# UNITED STATES PATENT AND TRADEMARK OFFICE

APPLICATION NO.	FILING DATE	FIRST NAMED INVENTOR	ATTORNEY DOCKET NO.	CONFIRMATION NO.
10/721,575	11/24/2003	Rex W. Beasley	44737-Beasley	5801
26252	7590	12/20/2004	EXAMINER	
KELLY BAUERSFELD LOWRY & KELLEY, LLP 6320 CANOGA AVENUE SUITE 1650 WOODLAND HILLS, CA 91367			HORTON, YVONNE MICHELE	
		ART UNIT		PAPER NUMBER
				3635

<b>Office Action Summary</b>	<b>Application No.</b>	<b>Applicant(s)</b>	
	10/721,575	REX W. BEASLEY <i>6</i>	
	<b>Examiner</b>	<b>Art Unit</b>	
	Yvonne M. Horton	3635

**DETAILED ACTION**

EXAMINER'S ATTACHMENT

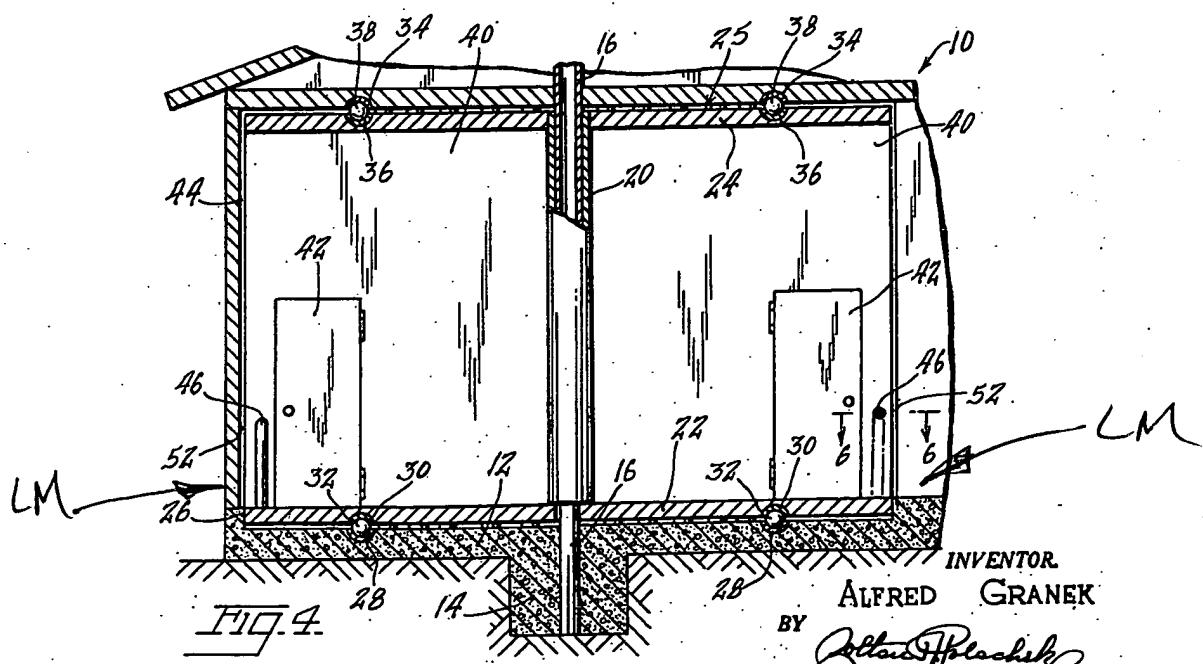
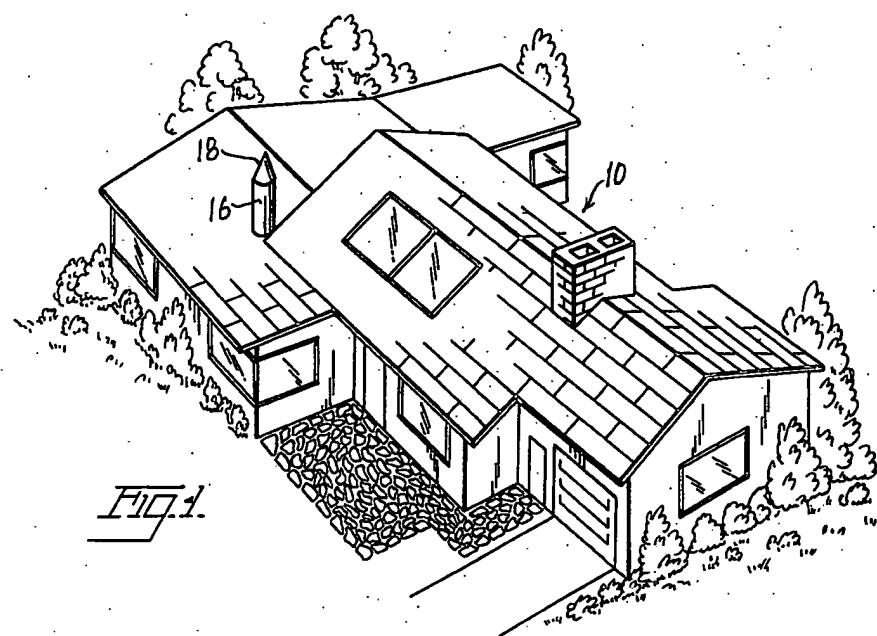
Claim 35 is rejected under 35 U.S.C. 102(b) as being anticipated by US Patent #2,823,425 to GRANEK. GRANEK discloses a movable wall module for installation into an opening formed in a wall (44) of a building wherein the building wall (44) separates first (FS) and second spaces (62) each including a stationary floor (FL) disposed respectively at opposite sides of the building wall (44), said movable wall module comprising:

a generally upright module frame (25,40) having generally vertical first and second sides extending upwardly from a lower margin (LM) wherein in the absence of an intervening turntable (as at 22) is disposed adjacent a stationary floor (FL) and (as at 58) of the first space (FS) and the second space (62); first component means (FC) supported on said first side (FS) of said frame (25,40) and second component means (SC) supported on said second (SC) side of said frame (25,40) and disposed in direct overlying to the stationary floors (FL) and (as at 58); and means (32,38) for movably supporting said frame (25,40) within the building wall opening for movement between a first position with said first and second (FC,SC) component means presented respectively to

said first (hatch lined) and second spaces, and a second position with said first and second component means (FC,SC) presented respectively to said second and first spaces (hatch lined), and further wherein the stationary floor area (F) within said first (FS) and second spaces is substantially exposed and unobstructed by said frame (25,40), when said frame (25,40) is in either one of said first (hatch lined) and second positions, see the marked attachment.

Claim 24,25,37 and 40 are rejected under 35 U.S.C. 102(b) as being anticipated by US Patent #2,823,425 to GRANEK. GRANEK discloses a movable wall module for installation into an opening formed in a wall (44) of a building wherein the building wall (44) separates first (FS) and second spaces (62) each including a stationary floor (FL) disposed respectively at opposite sides of the building wall (44), said movable wall module comprising:

a generally upright module frame (25,40) having generally vertical first and second sides extending upwardly from a lower margin (LM) wherein in the absence of an intervening turntable (as at 22) is disposed adjacent a stationary floor (FL) and (as at 58) of the first space (FS) and the second space (62); first component means

(FC) supported on said first side (FS) of said frame (25,40) and second component means (SC) supported on said second (SC) side of said frame (25,40) and disposed in direct overlying to the stationary floors (FL) and (as at 58); and means (32,38) for movably supporting said frame (25,40) within the building wall opening for movement between a first position with said first and second (FC,SC) component means presented respectively to said first (hatch lined) and second spaces, and a second position with said first and second component means (FC,SC) presented respectively to said second and first spaces (62), and further wherein the stationary floor area (FL) and (as at 58) within said first (FS) and second spaces is substantially exposed and unobstructed by said frame (25,40), when said frame (25,40) is in either one of said first (hatch lined) and second positions, see the marked attachment.
